TURKEY POINT NUCLEAR GENERATING STATION UNIT NO. 3

Amendment No. 68
License No. DPR-31

Amendment No. 60
License No. DPR-41

SAFETY EVALUATION BY THE OFFICE OF NUCLEAR REACTOR REGULATION
RELATED TO AMENDMENT NO. 68 TO FACILITY OPERATING LICENSE NO. DPR-31
AND AMENDMENT NO. 60 TO FACILITY OPERATING LICENSE NO. DPR-41
FLORIDA POWER AND LIGHT COMPANY
TURKEY POINT PLANT UNIT NOS. 3 AND 4
DOCKET NOS. 50-250 AND 50-251

HOT CHANNEL FACTOR
NORMALIZED OPERATING ENVELOPE

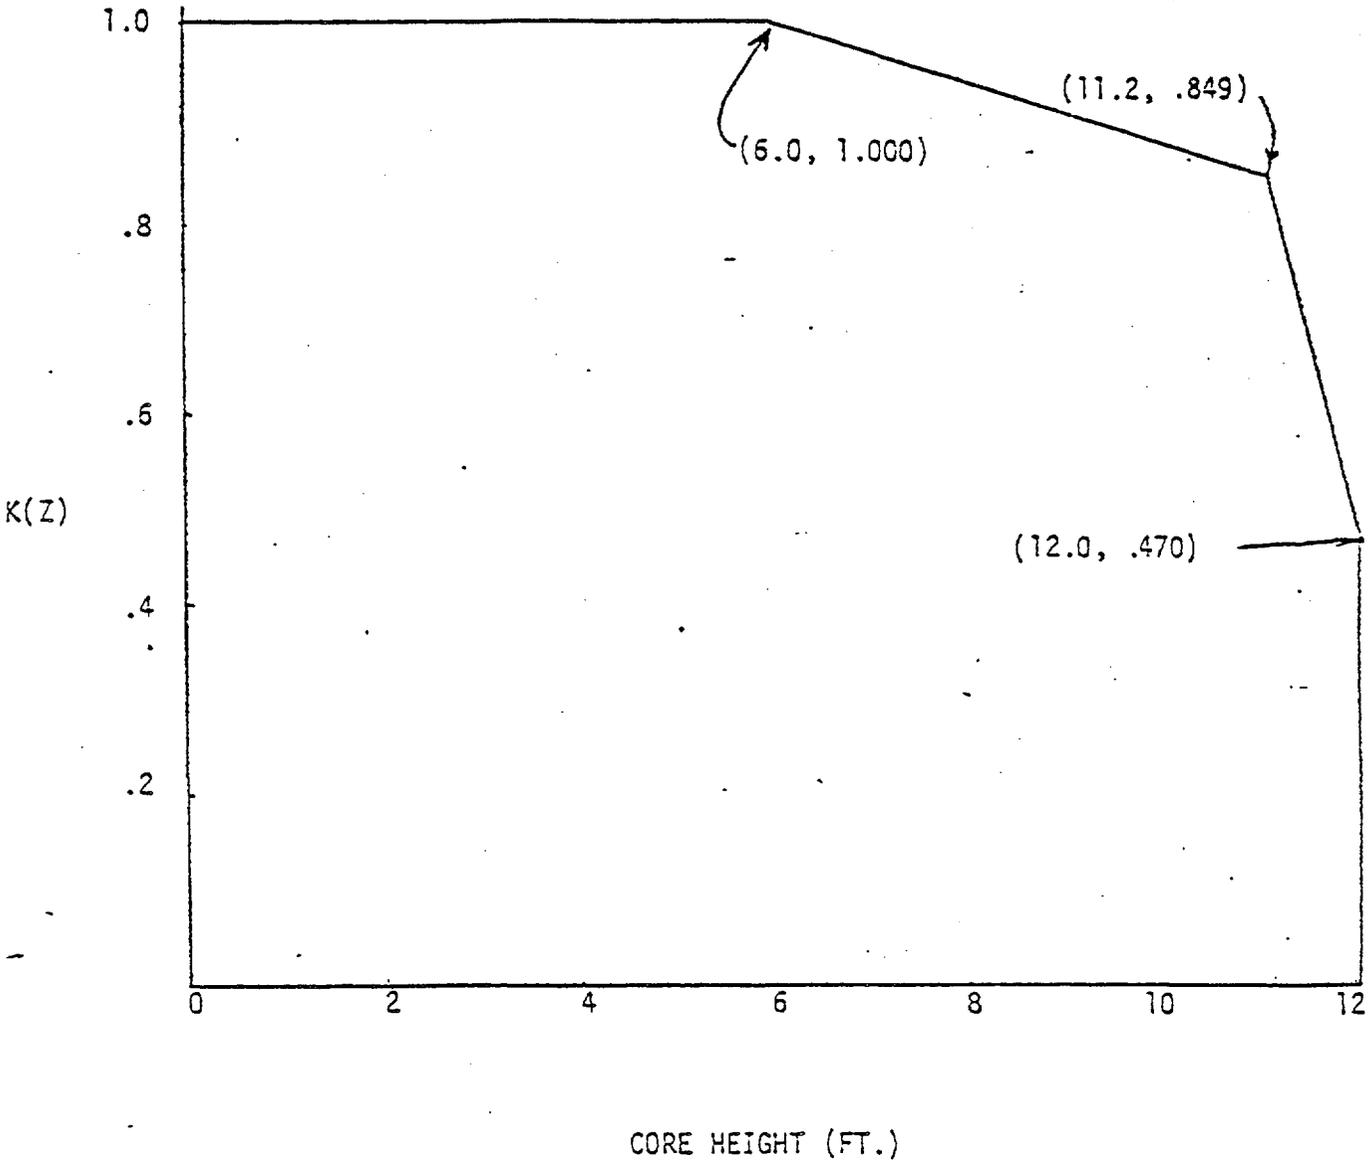
f. Figure 3-2-3

The $K(Z)$ curve has been modified to reflect the new steam generator tube plugging limit and new F_Q .

(for $\leq 28\%$ steam generator tube plugging and $F_q = 2.125$)

FIG. 2.1-16

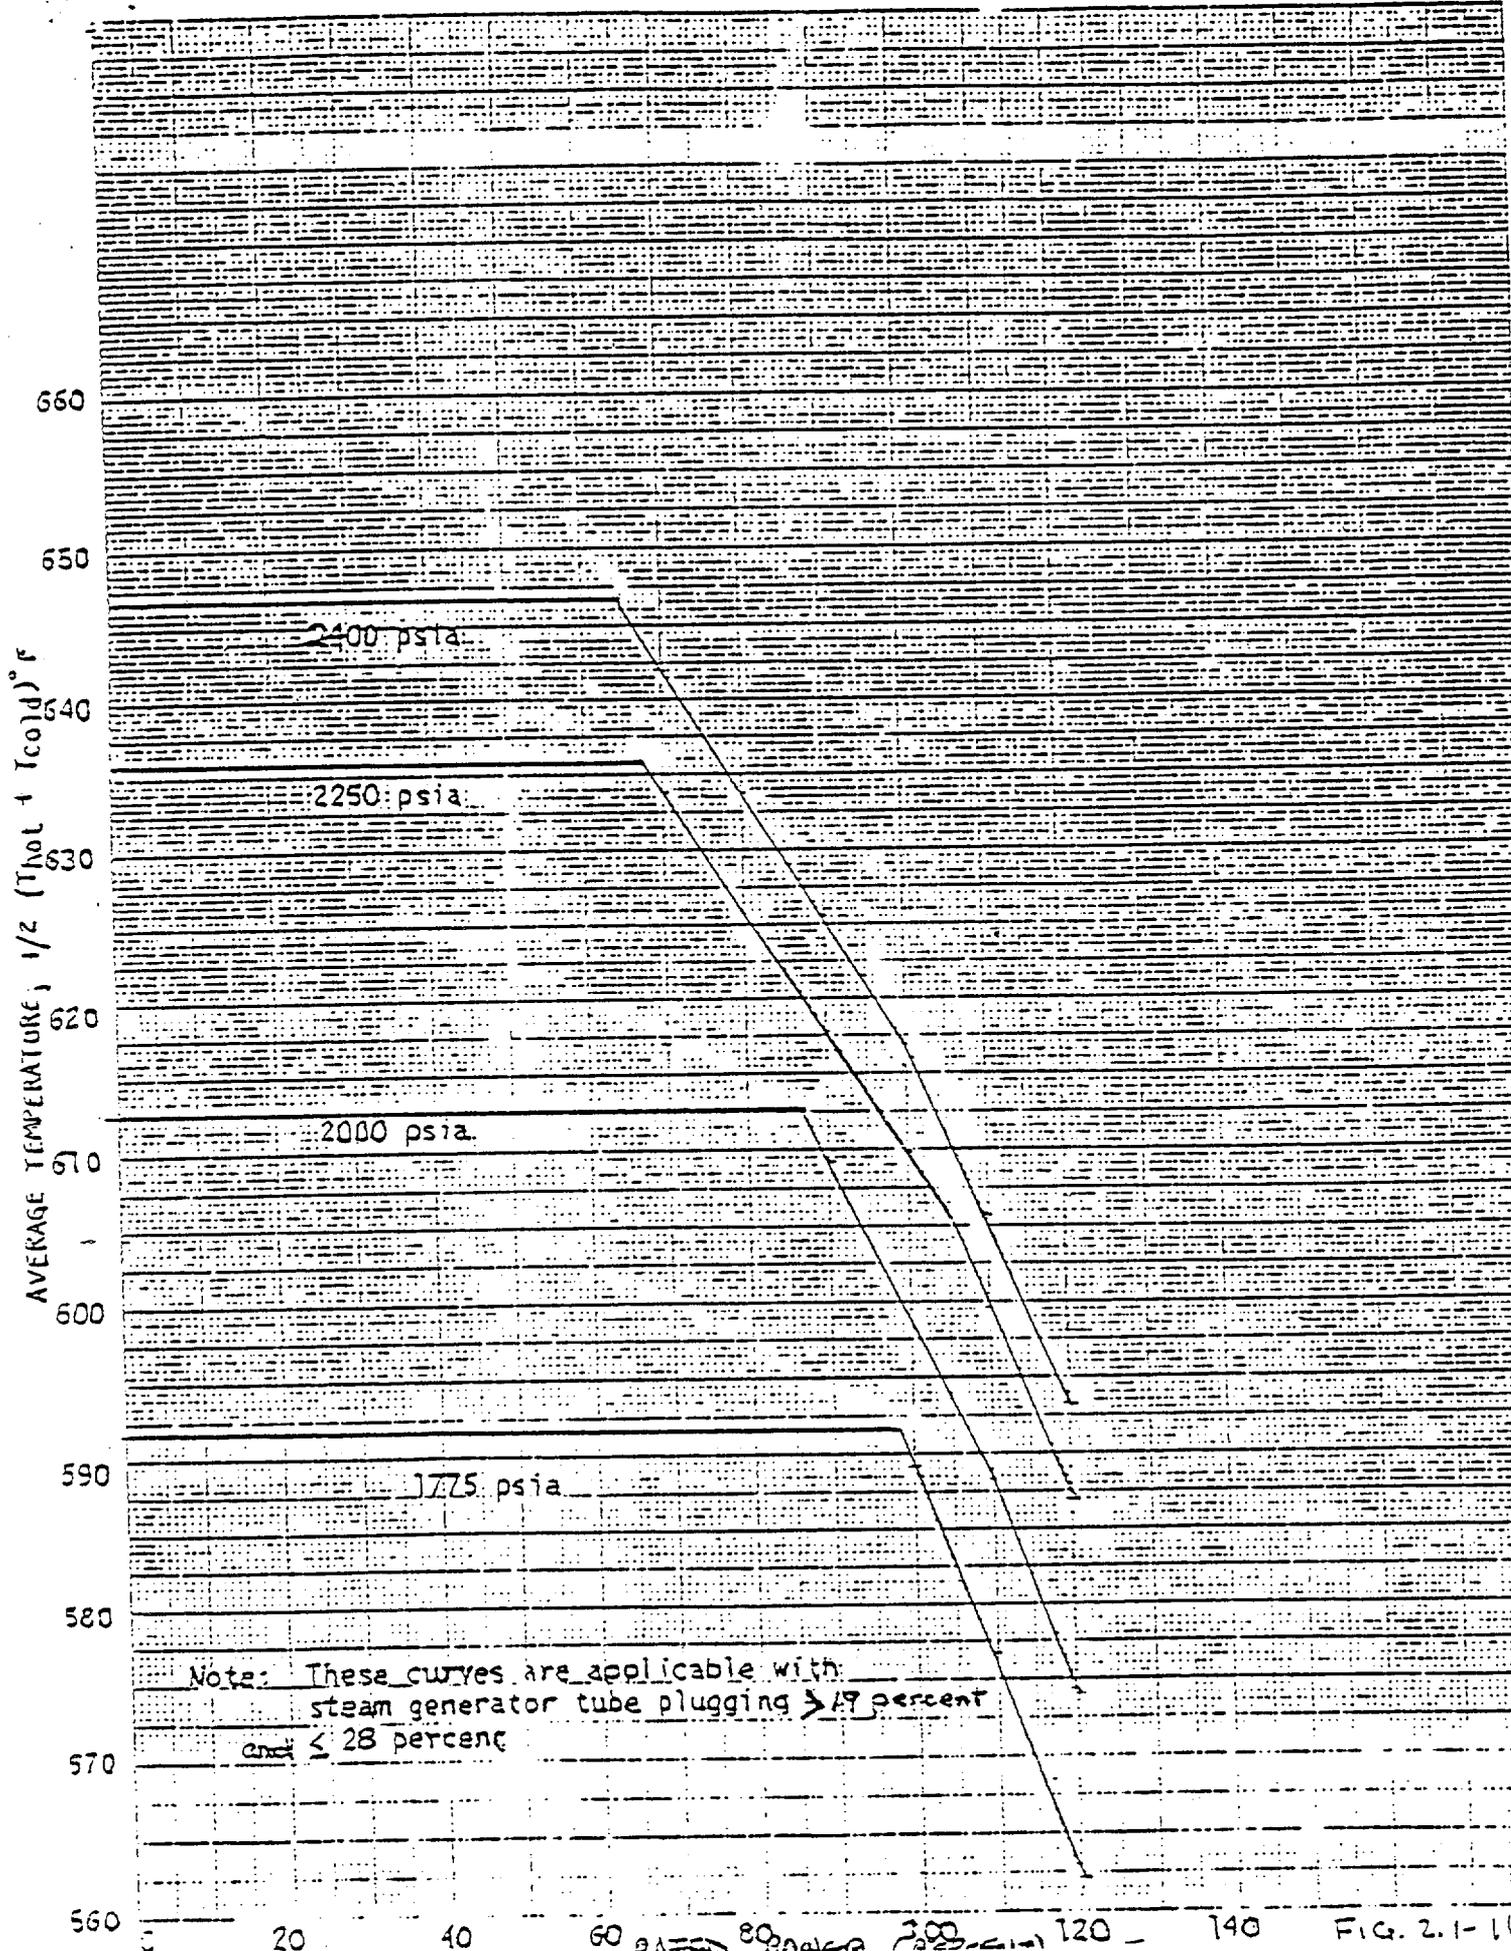
a. Figure 2.1-1b

The curve has been updated to reflect the new steam generator tube plugging limit, and has been corrected per our NSSS vendor's recommendation.
